UNITED STATES  
NUCLEAR REGULATORY COMMISSION  
WASHINGTON, D. C. 20555

SAFETY EVALUATION BY THE OFFICE OF NUCLEAR REACTOR REGULATION  
RELATED TO PRESSURIZER HEATER TRANSFORMER BARRIER DESIGN  
TO FACILITY OPERATING LICENSE NO. NPF-16  
FLORIDA POWER AND LIGHT COMPANY ET AL.  
ST. LUCIE PLANT, UNIT NO. 2  
DOCKET NO. 50-389

FIGURE 1

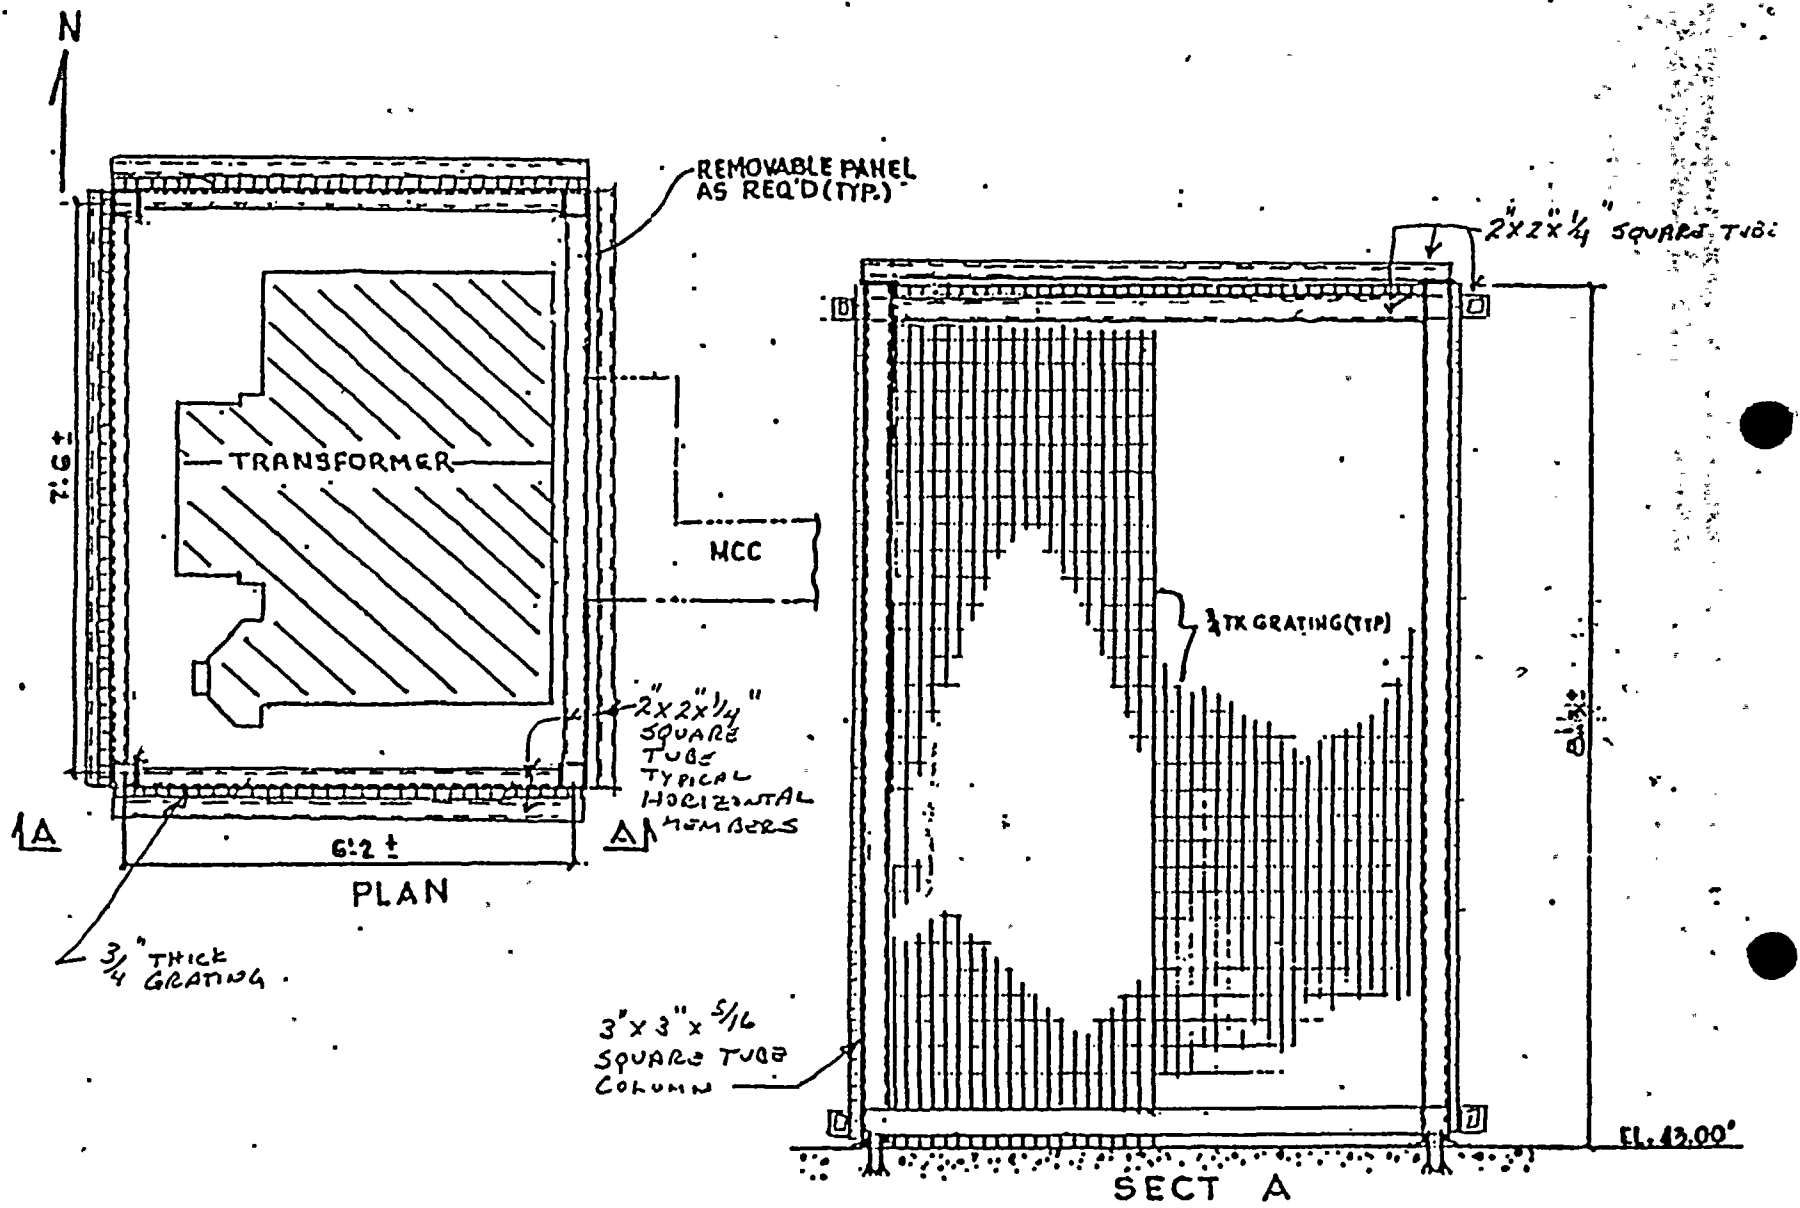
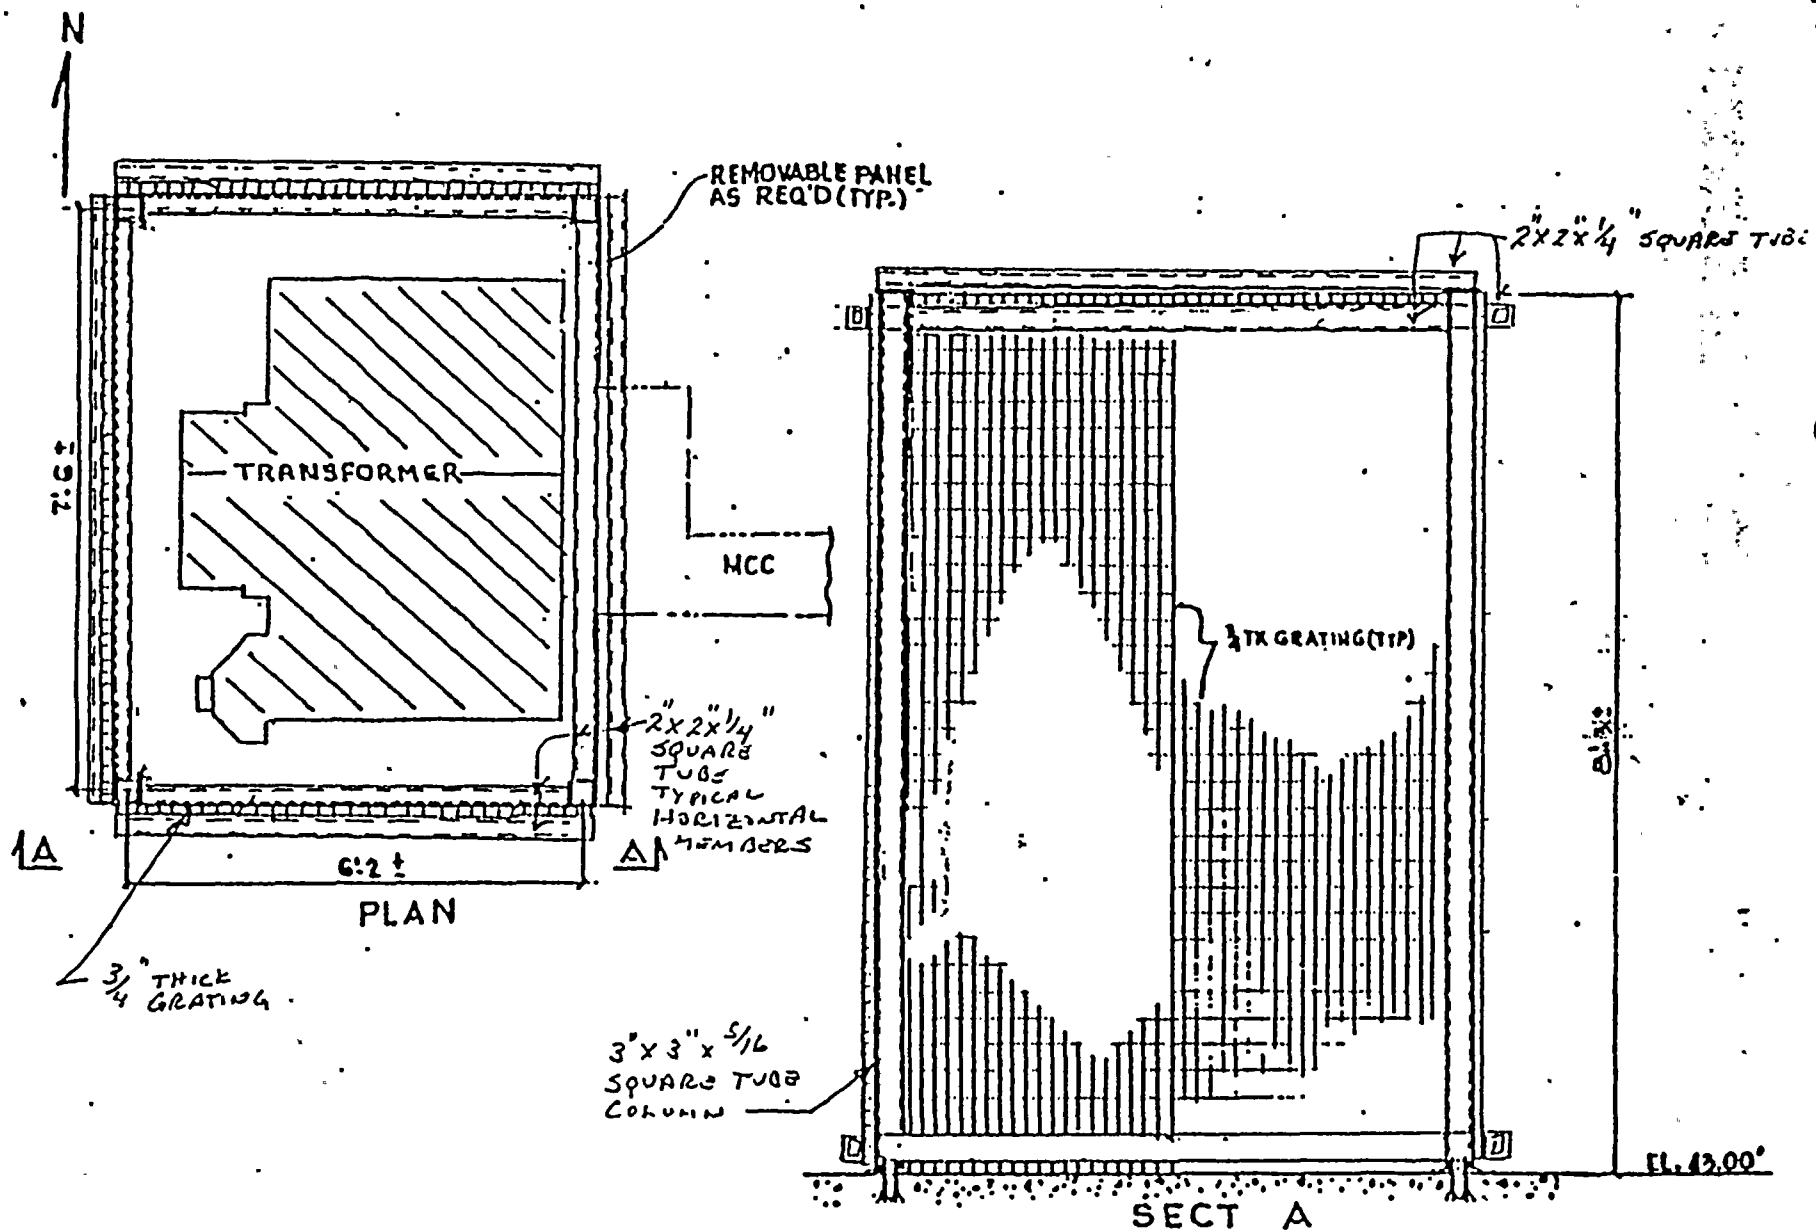
Details of the barrier are shown in Figure 1. The frame of the barrier is constructed of square tube columns and square tube horizontal members. This frame is anchored to the concrete floor by four expansion anchor bolts at two corners and five expansion anchor bolts at the other two corners. The grating is composed of bars spaced at 1-3/16 inches on center, sandwiched between the supporting frame and horizontal square tubing bolted to the frame. Where small missiles could penetrate the spacing between the grating bars, 3/4 inch flat steel plates were welded to the transformer side of the grating to stop the potential missile.

The staff has reviewed the February 27, 1984, licensee submittal and subsequent information provided by the licensee. Methods used to determine the required missile barrier thickness and to include effects of seismic loads are acceptable. Also, the steel plates welded to the inside face of the grating to prevent exit of potential small missiles were properly analyzed and designed.

The design is adequate to prevent the potential missiles described from exiting the barrier. Therefore the design, as presented, is acceptable.
